ADDENDUM NO. 2

BID NO. 2838

**CLOVIS EAST HIGH SCHOOL CTE FARM AND FOOD PRODUCT FACILITY
CLOVIS UNIFIED SCHOOL DISTRICT
CLOVIS, CALIFORNIA**

G.A. PROJECT NO. 1739

S2.1

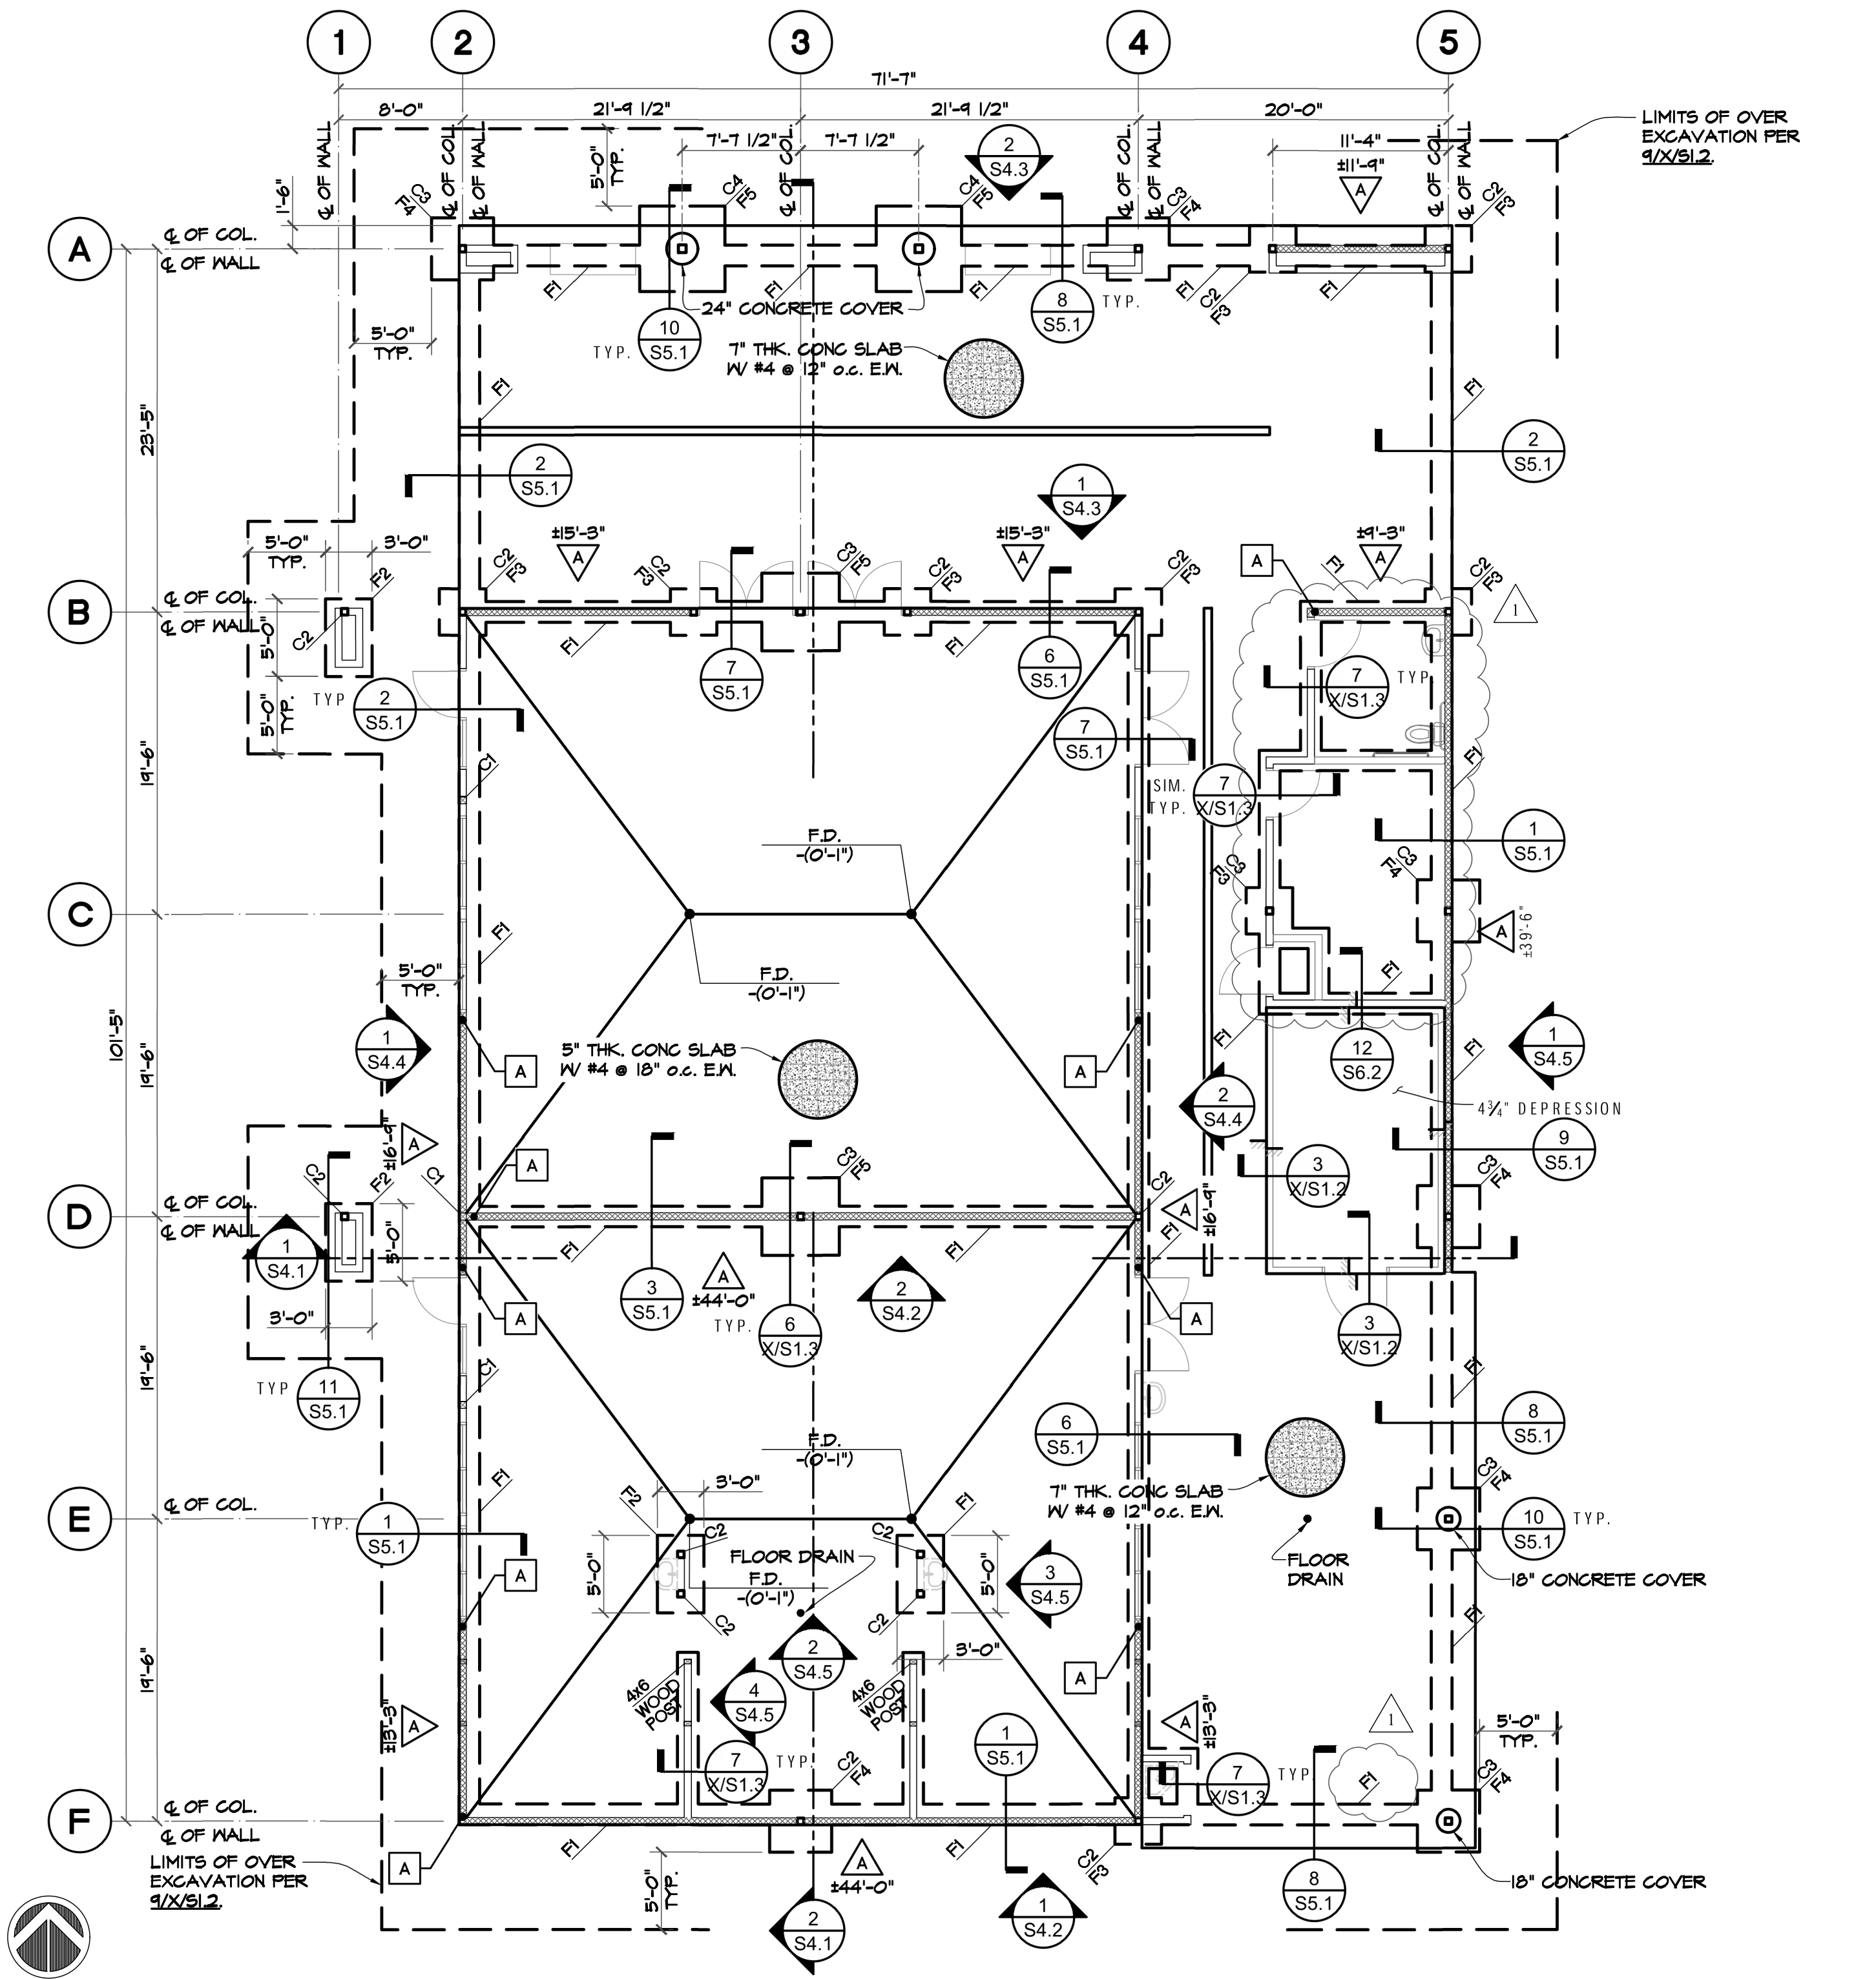
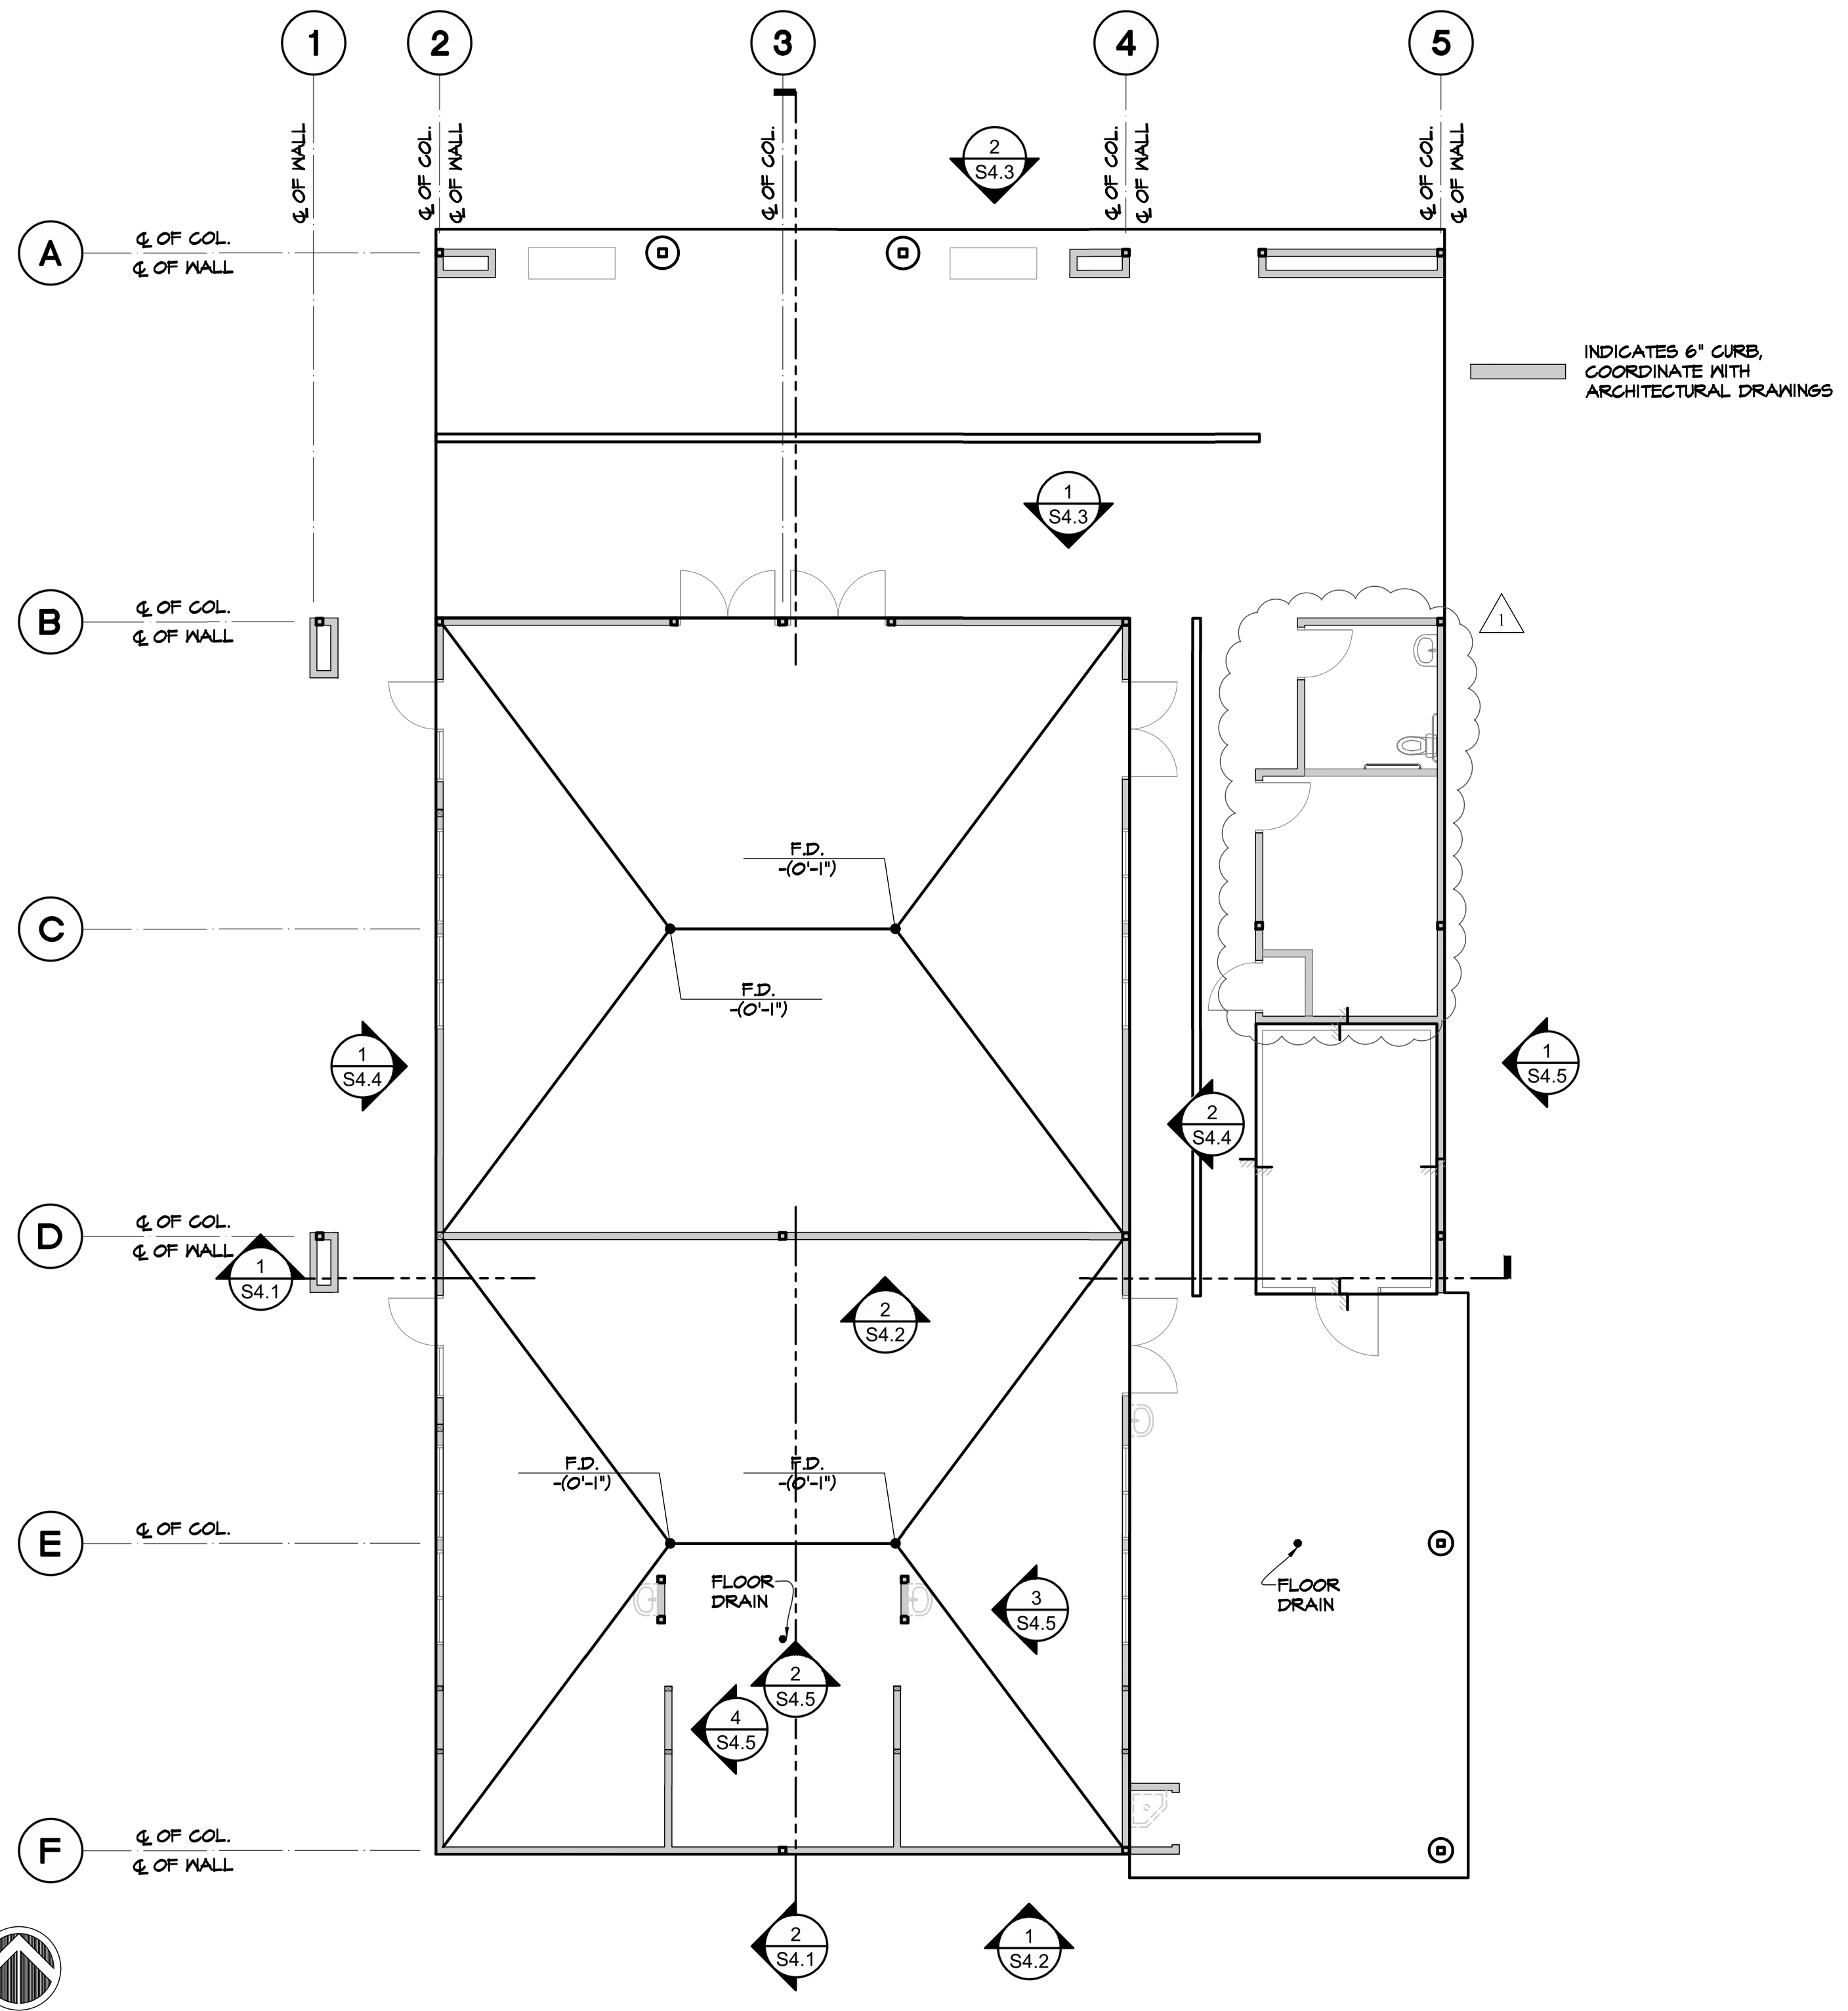
S2.1:

1.) Revised and clarified footing call outs and structural walls.
